ADDENDUM NO. 1  
TO THE CONTRACT DOCUMENTS  
for the construction of  
SPANISH FORK SANTAQUIN PIPELINE  
SANTAQUIN REACH  
Contract C-2023-01

Date: October 23, 2023  
Project No.: W7Y29003

PLAN AND PROFILE STA 801+00 TO STA 810+00		SHEET	X OF XX
		DWG	PP-90
		DATE	OCTOBER 2023
		CONTRACT	C-2023-01

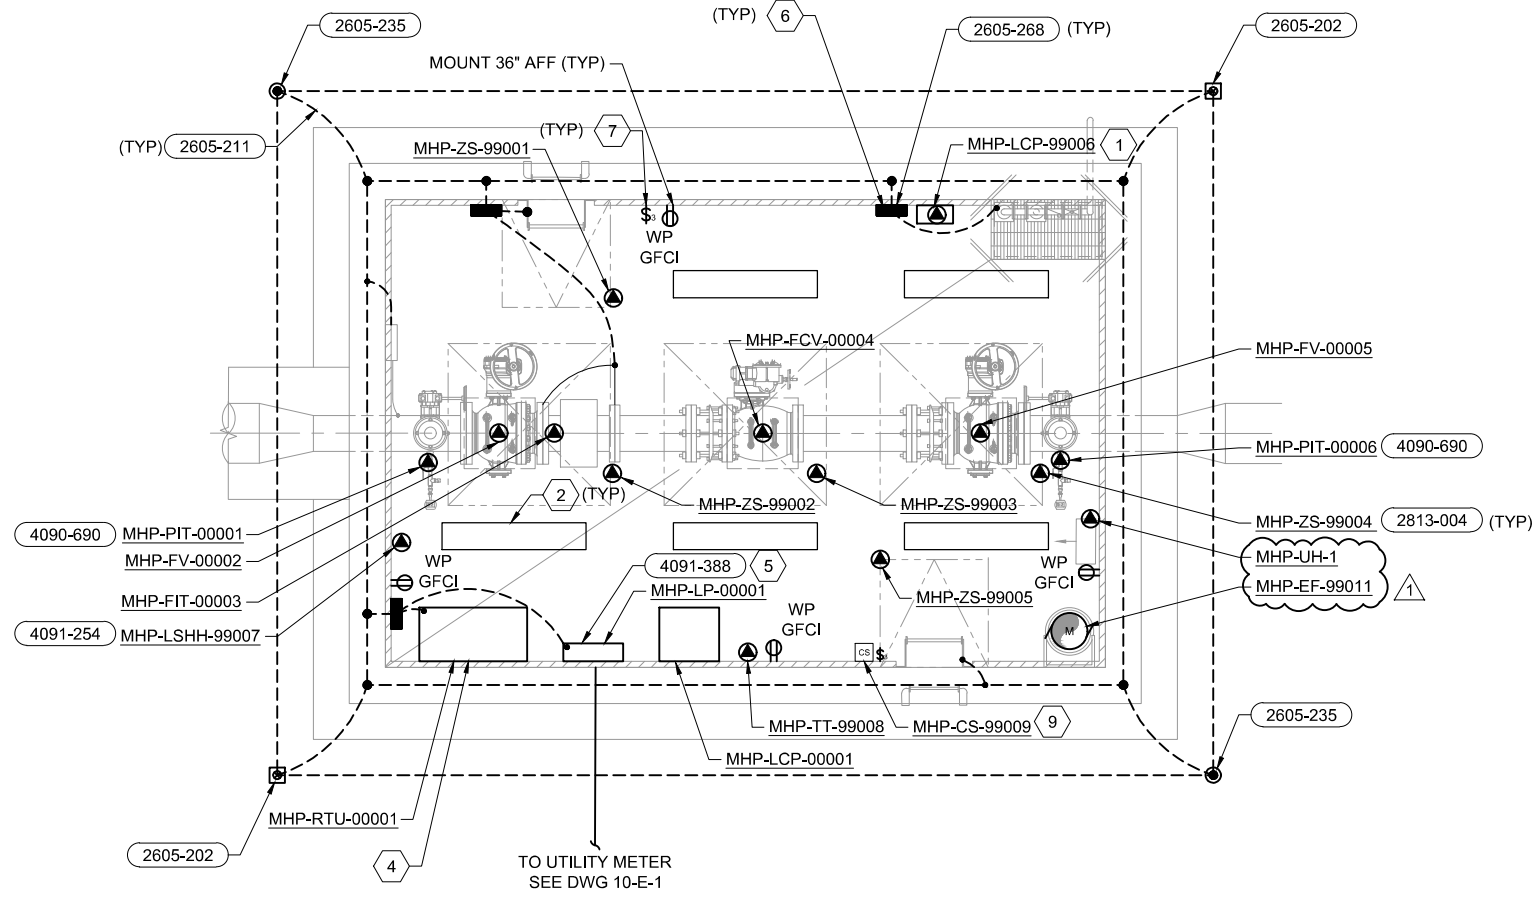
1. Drawing No. PP-90, Plan and Profile STA 801+00 to STA 810+00. DELETE in its entirety and REPLACE with the attached.
2. Drawing No. GE-2, General Electrical Notes, Legend, and Abbreviations. DELETE in its entirety and REPLACE with the attached.

DSGN	J HANSEN	NO. 10/23 ADD1 - MODIFIED TURNOUT SITE ELEVATIONS REVISION	RP	AS
DR	R PHILLIPS		BY	APVD
CHK	A MURDOCK			
APVD	A SMITH
